BREWSTER CENTRAL SCHOOL DISTRICT
CV STARR INTERMEDIATE SCHOOL
CAFETORIUM ADDITION, INTERIOR RENOVATIONS & RELATED WORK
ADDENDUM NO. 1

ADDENDUM NO. 1

DATE: December 20, 2024

This addendum consists of 2 pages plus revised Bid Form – Contract #1 General Construction, Logistics drawings CVS L100, CVS L101, CVS L103, CVS L104, revised drawings CVS C401, CVS C402, CVS C403, CVS C404, CVS C405 and CVS C606, specification section 21 1313 Wet Pipe Sprinkler System and Sketch SK-A1.0.

NEW CLASS 52 DIP
FIRE WATER SERVICE

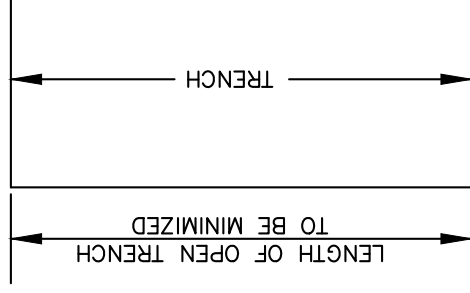
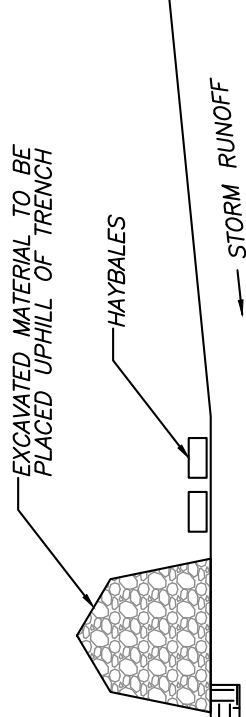
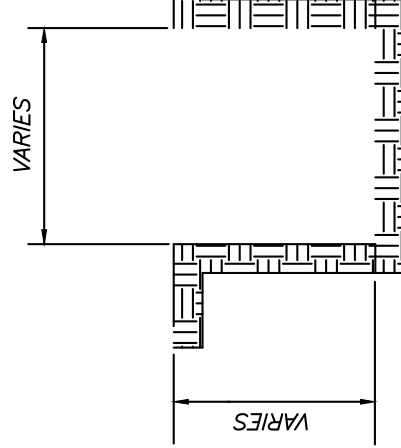
PROVIDE 5" CONCRETE SLAB
INFILL OVER VAPOR BARRIER,
6" CRUSHED STONE AND
COMPOSTED FILL AFTER
INSTALLATION OF SPRINKLER
MAIN.

UTILITY TRENCH EXCAVATION EROSION CONTROL DETAIL

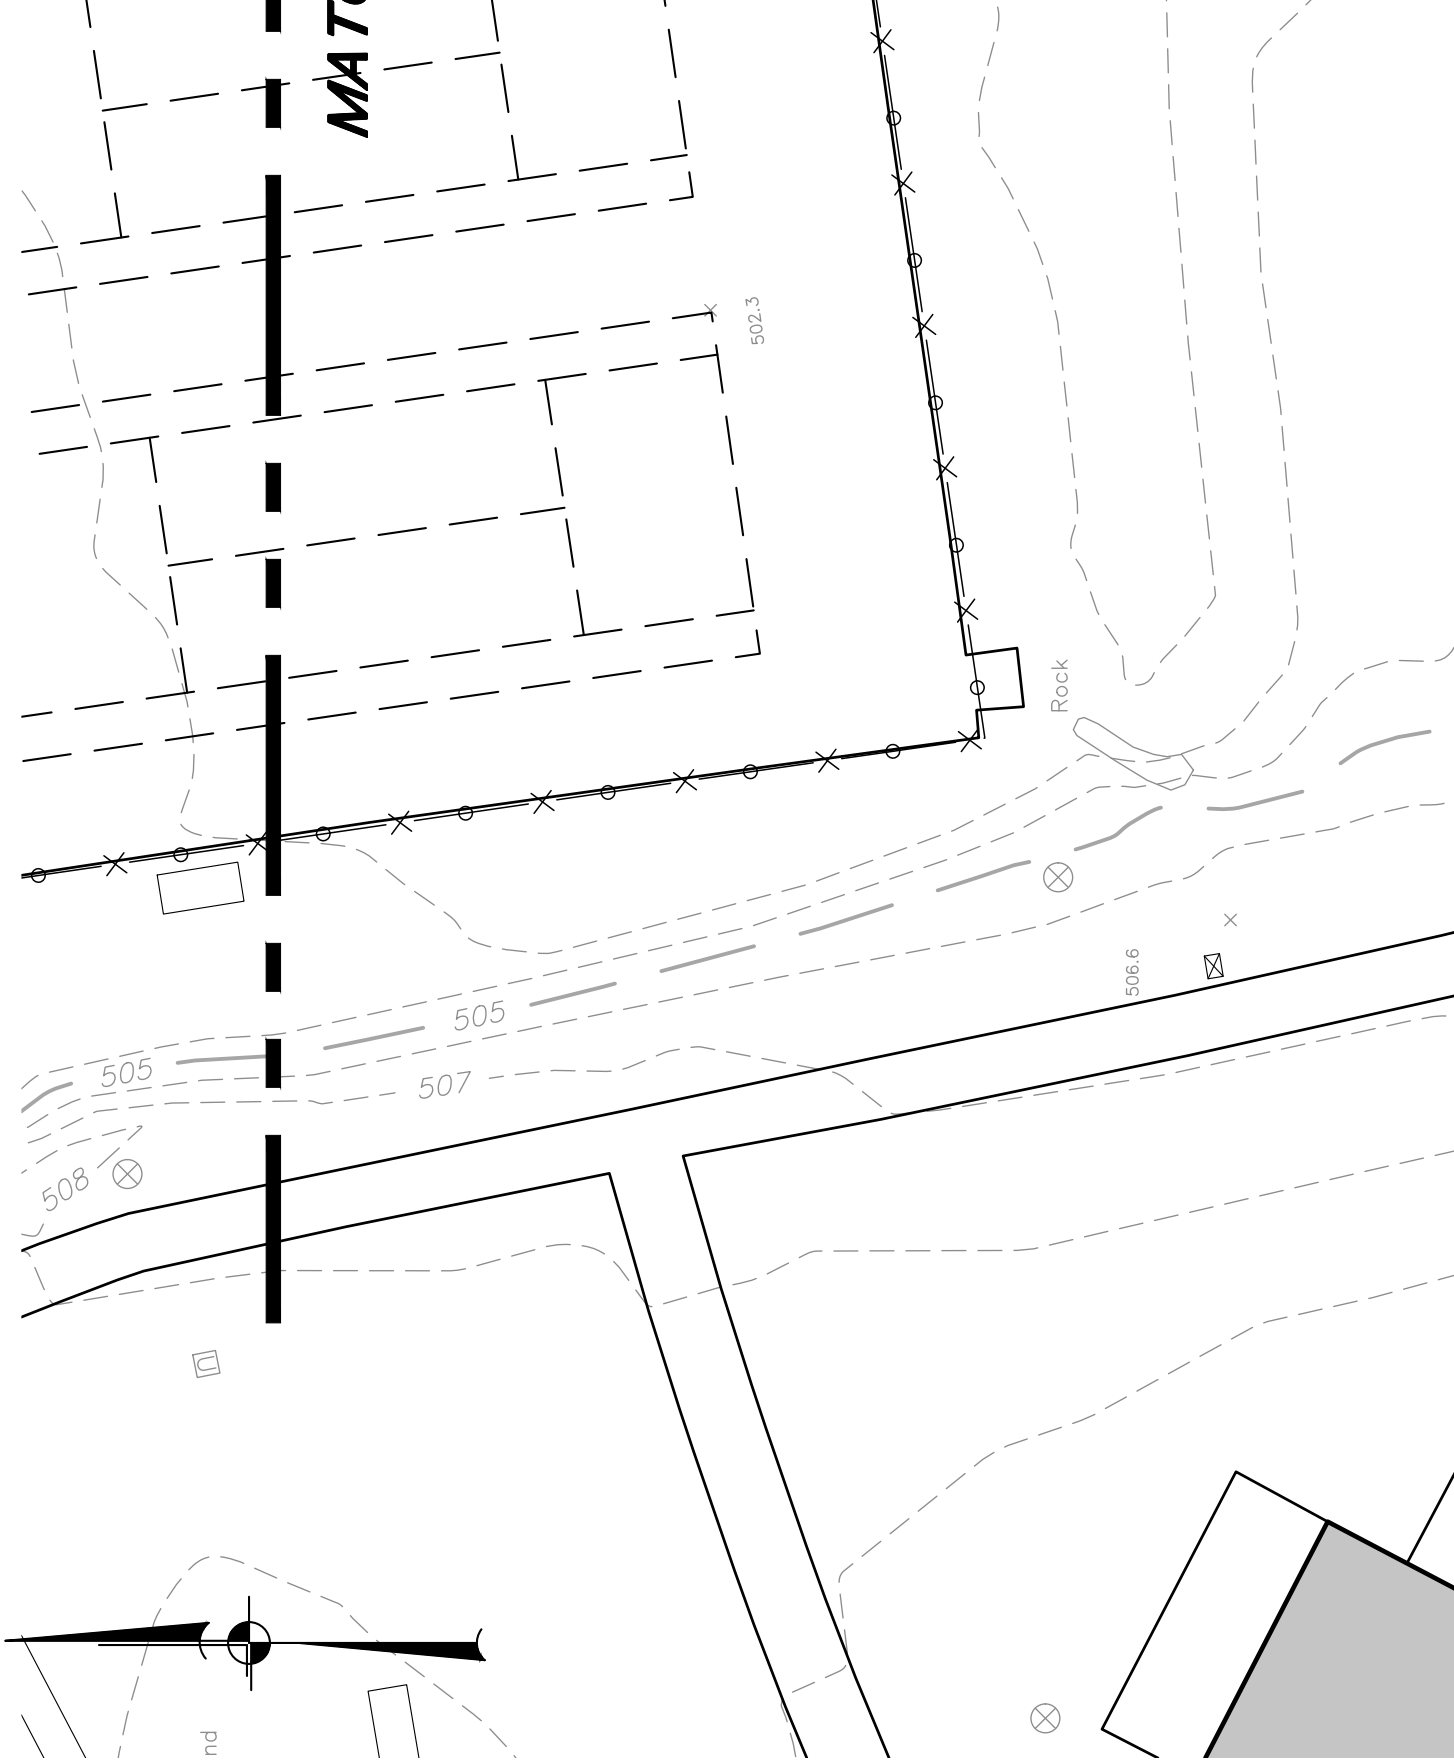
- NOTES:
1. THE LENGTH OF TRENCH OPEN AT ONE TIME SHALL BE MINIMIZED.
 2. IMMEDIATELY AFTER BACKFILLING TRENCH STABILIZE GROUND IN ACCORDANCE WITH THE EROSION CONTROL NOTES.
 3. TRENCH EXCAVATIONS THAT MUST BE LEFT OPEN OVERNIGHT SHALL HAVE HAYBALES INSTALLED AT THE LOW END OF THE TRENCH AND AT THE TOE OF THE EXCAVATED MATERIAL.
